JAMES A. FITZPATRICK NUCLEAR POWER PLANT

AMENDMENT TO FACILITY OPERATING LICENSE

Amendment No. 30
License No. DPR-59

ATTACHMENT TO LICENSE AMENDMENT NO. 30

FIGURE 3.5-2 MAXIMUM AVERAGE PLANAR LINEAR HEAT GENERATION RATE

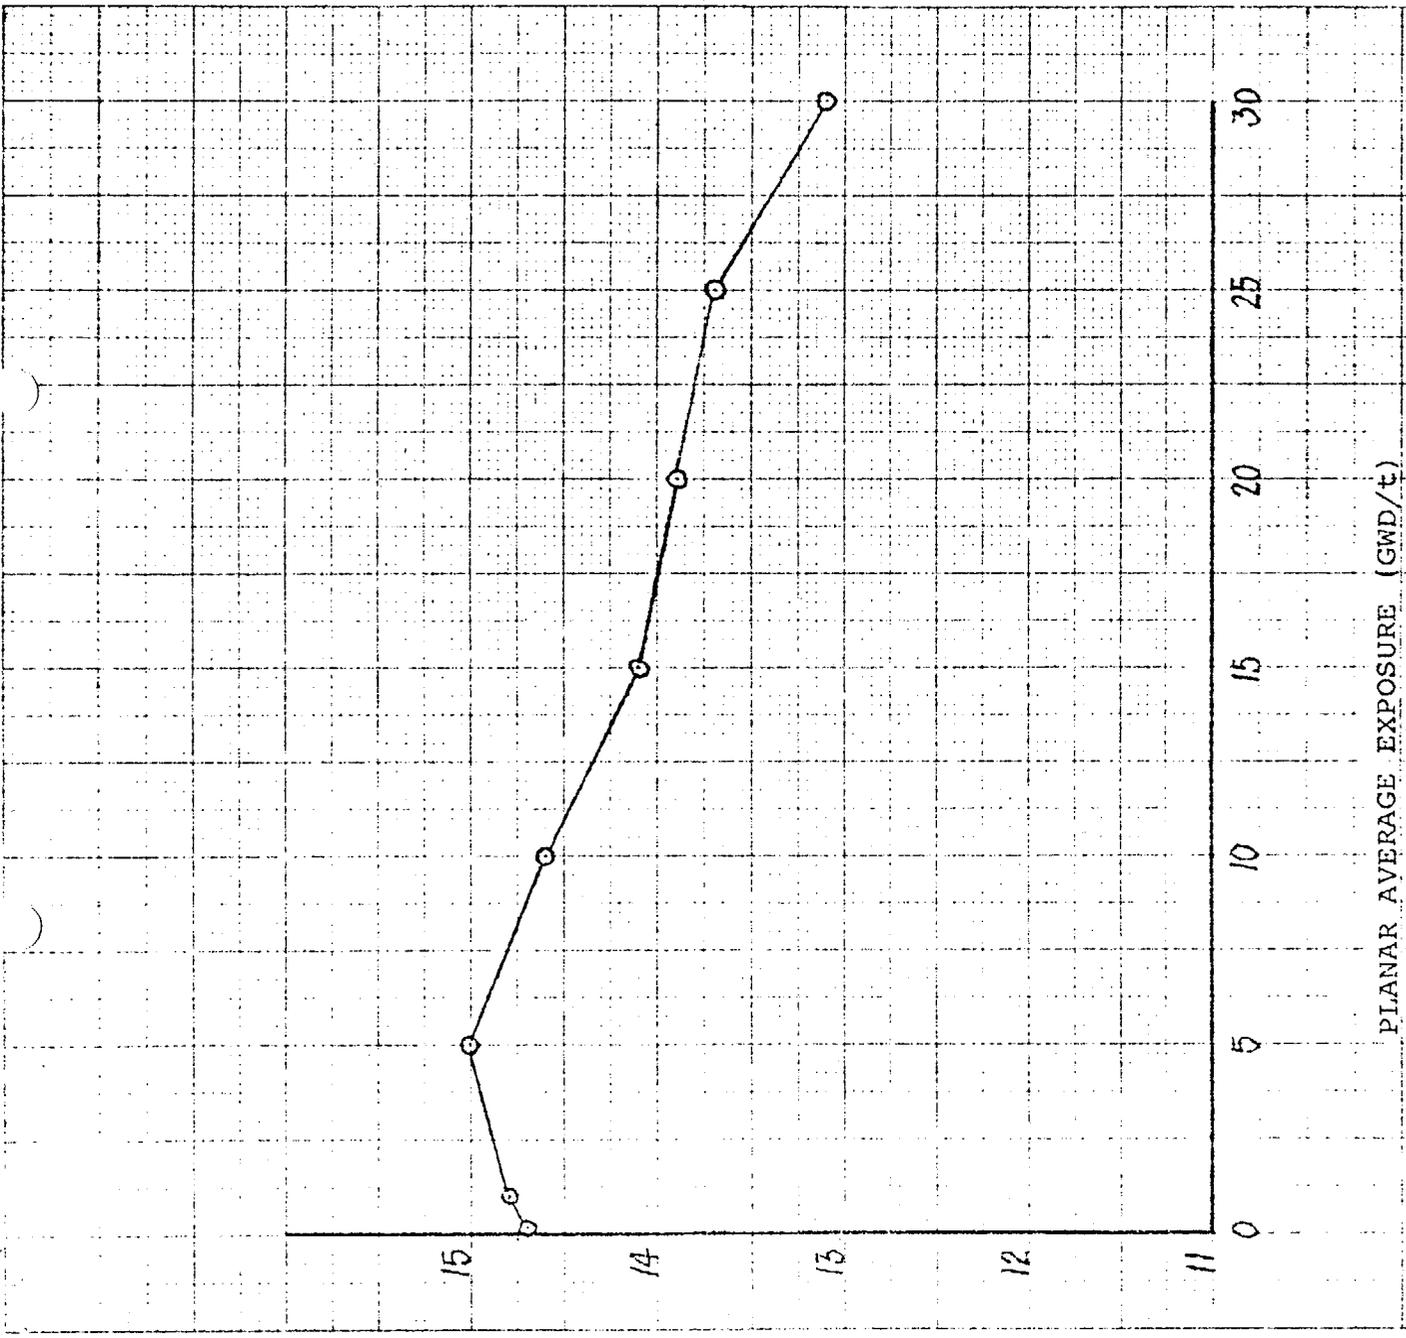
The APLHGR for each type of fuel as a function of average planar exposure shall not exceed the limiting value shown in Figures 3.5.1, 3.5.2 and 3.5.3. If at any time it is determined that the limiting value for APLHGR is being exceeded action shall then be initiated within 15 minutes to restore operation to within the prescribed limits. If the APLHGR is not returned to within the prescribed limits within two (2) hours, the reactor shall be brought to the Cold Shutdown condition within 36 hours. Surveillance and corresponding action shall continue until reactor operation is within the prescribed limits.

are within the 10 CFR 50 Appendix K limit. The limiting value for APLHGR is shown in Figure 3.5.1, 3.5.2 and 3.5.3.
